UNITED STATES
NUCLEAR REGULATORY COMMISSION

SUBJECT: NRC SPECIAL INSPECTION REPORT - INDIAN POINT UNIT 2
STEAM GENERATOR TUBE FAILURE - REPORT NO. 05000247/2000-010

Report No. 05000247/2000-010

Facility: Indian Point 2 Nuclear Power Plant

Figure 5 - Crack in tube 2-67 of steam generator 24, found in 1997.

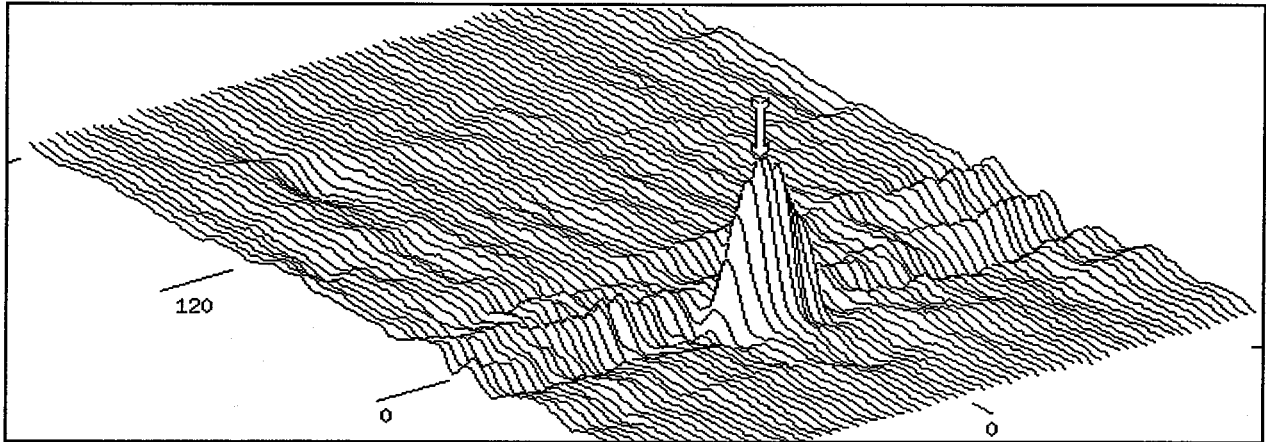
The c-scan plot of the 1997 data from R2C67 is shown in Figure 5. The crack sits beside a noise ridge, in a valley, and is in an easily detectable portion of the tube. The large amplitude of the voltage signal, in relation to the standard calibration notch, would indicate that this is a "mature" crack. No year 2000 data is available since the tube was plugged in 1997.

Figure 6 R2C5C-scan with 1997 phase setting.

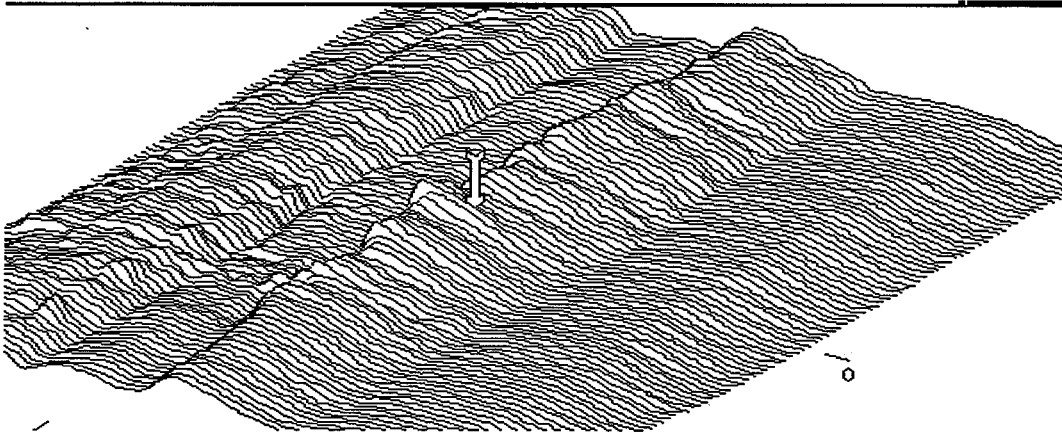
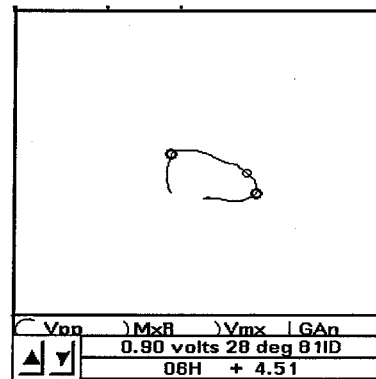
1. R2C5 in SG 24 - Figure 6 is a c-scan plot of the vertical component of the ECT voltage signal. The defect signal, indicated by the arrow, sits on a noise ridge that runs the length of the tube. This noise ridge is about 1-volt in amplitude. This ridge makes both the detection and sizing of this defect difficult, because of the very low signal-to-noise ratio. Figures 7 and 8 are the lissajous plots for the flaw area and the noise ridge, respectively. No year 2000 data is available since the tube failed.

Figure 9 - 1997 mid-range scan

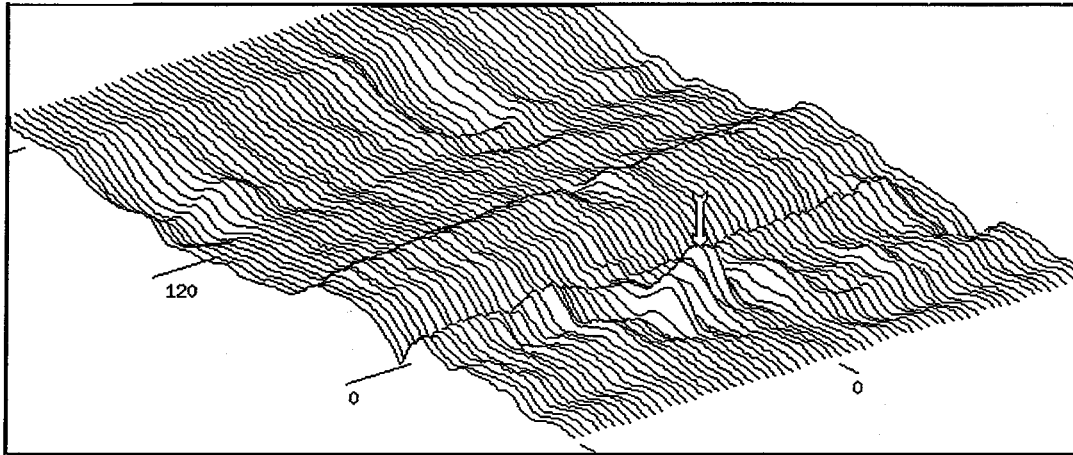
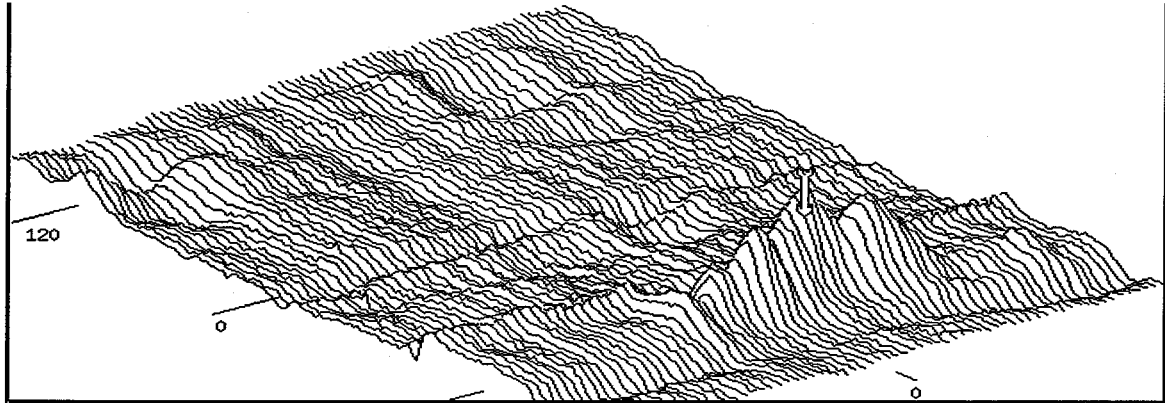
2. R2C69 in SG 24 - Figure 9 shows the c-scan plot for the 1997 data. There is considerable noise present. For comparison, the c-scan plot for the 2000 data is included as Figure 10. The noise features between the 1997 and 2000 data are similar enough to verify that this is the same defect at the same location. The defect voltage is only about 1 volt, and there is a considerable amount of noise on the tube relative to the defect signal, i.e., low signal-to-noise ratio.

Figure 12 - 2000 scan

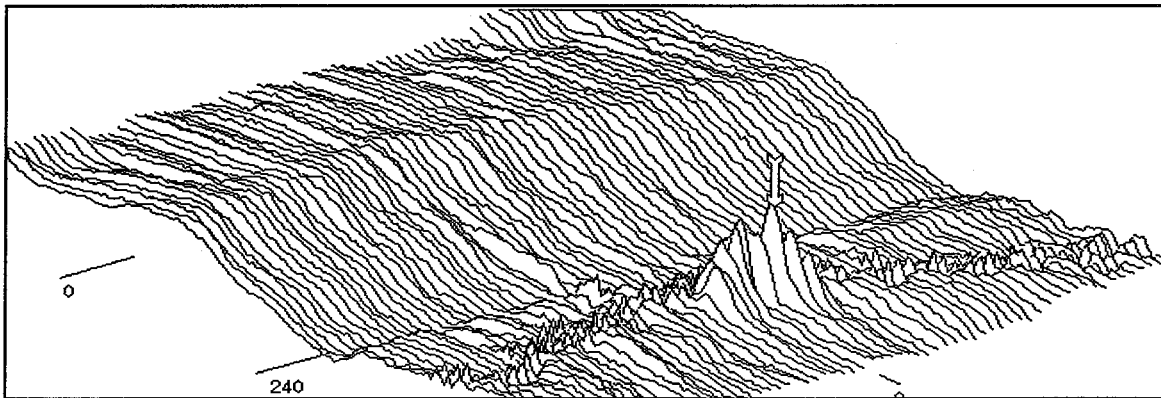
3. R2C72 in SG 24 - Figure 11 shows the c-scan plot of the 1997 data. There is considerable noise present. The crack is sitting in a ridge of noise and barely extends above the ridge. For comparison, the c-scan plot for the 2000 data is included as Figure 12. The crack barely extends above a 1-volt amplitude for a short length and exhibits a low signal-to-noise ratio.
4. R2C87 in SG 21 - this tube was identified as having several cracks. Figure 13 shows the c-scan plot of the 1997 data. The most prominent crack is sitting in a relatively clean area of the tube. For comparison, the c-scan plot for the 2000 data is included as Figure 14.
